# Water Quality Division RULE CLARIFICATION

<b>RC #:</b> 009	<b>Title:</b> 18	<b>Chapter:</b> 9	<b>Article:</b> 3	<b>Rule Citation:</b> R18-9-E302(C)(2)(a)
------------------	------------------	-------------------	-------------------	---

**Topic of Rule Needing Clarification:** Design criteria for calculating absorption area for shallow and deep trenches

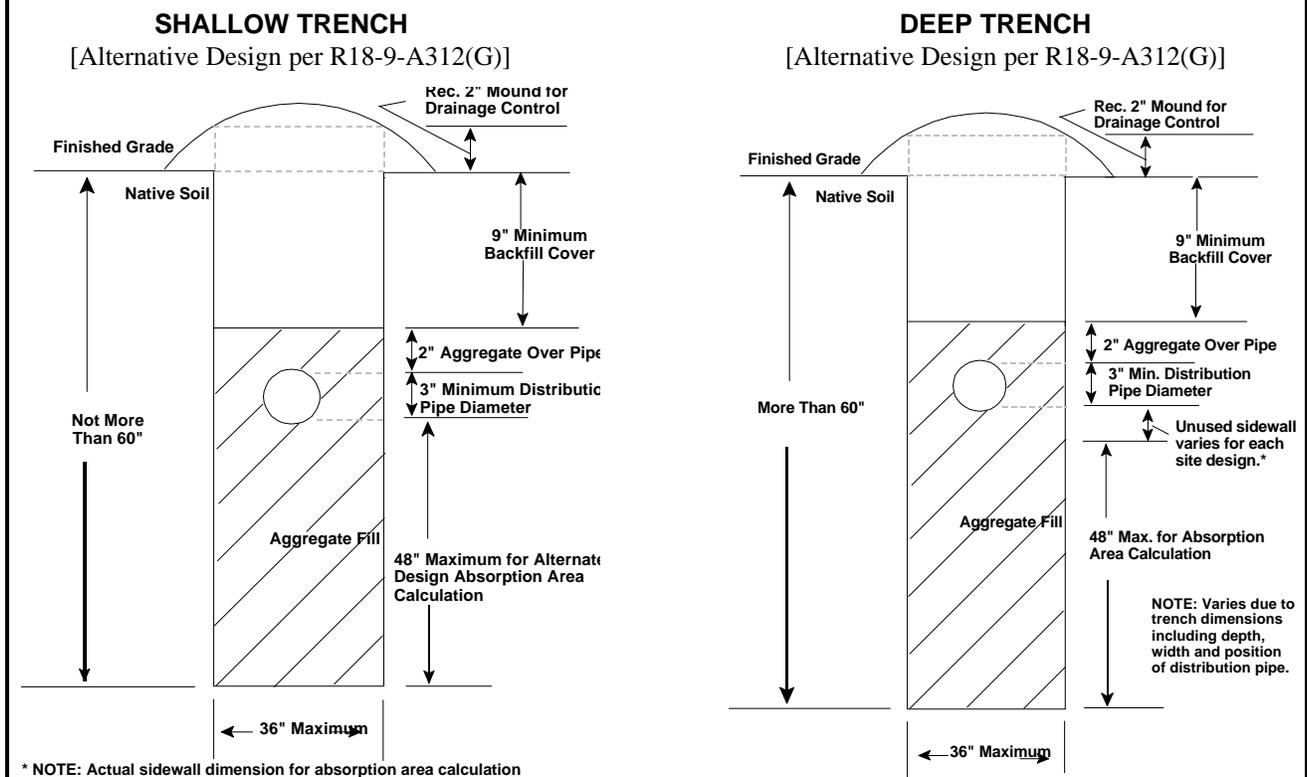
**Question Needing Clarification:** Please clarify the allowable sidewall area criteria. May other configurations be used in computing trench absorption area?

**Clarification of Rule:** The Department interprets this rule to mean that a trench must have at least 12 inches and may have as much as 36 inches of sidewall depth extending below the bottom of the distribution pipe. Thus, up to 9 square feet (ft<sup>2</sup>) of sidewall area per linear foot of trench (up to 3 ft<sup>2</sup> for each sidewall and 3 ft<sup>2</sup> for the trench bottom) may be used in the design without submitting an alternative design under the procedure described in R18-9-A312(G). An applicant may propose an alternative design under R18-9-A312(G), in areas where seasonal saturation of surface soils does not occur, that includes up to a nominal 11 ft<sup>2</sup> of absorption area per linear foot of trench (up to 3 ft<sup>2</sup> for the trench bottom and a nominal 4 ft<sup>2</sup> for each sidewall). For such an alternative design, especially for a shallow trench installation using the maximum sidewall distance shown below (resulting in an absorption area of a nominal 11 ft<sup>2</sup> per linear foot of trench after rounding), the designer must consider the elevations and slopes of the land surface, trench bottom and distribution pipe if approval of the nominal 11 ft<sup>2</sup> is desired. The applicant shall submit a profile drawing of the treatment and disposal components, to scale with critical horizontal and vertical measurements indicated, to allow the reviewing agency to verify absorption area and distribution pipe depth along the entire length of the trench. The reviewing agency may approve the design if the system will operate properly and perform equivalently to similar designs in similar soils and site conditions that the reviewing agency has approved in the past. Sidewall measurement is from the bottom of the distribution pipe (to a maximum of 5 feet below finished grade in a shallow trench). Cross-sections of shallow and deep trenches based on the alternative design procedure are shown below.

NOTE: Varies due to trench dimensions including depth, width and position of distribution pipe.
